POST OCCUPANCY EVALUATION

ORMISTON PRIMARY SCHOOL Flat Bush, Auckland

March 2016

Figure 17

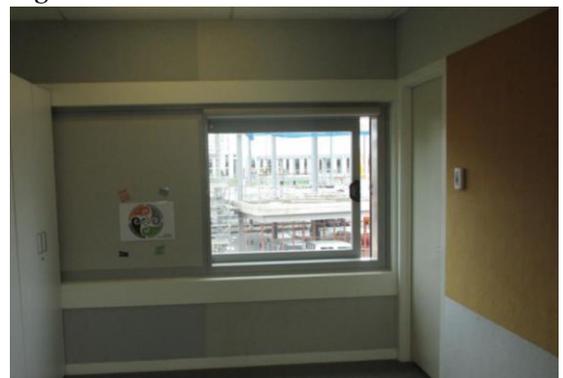
Temporary fencing was in place to the south and west of the school, where construction on the junior college was taking place.
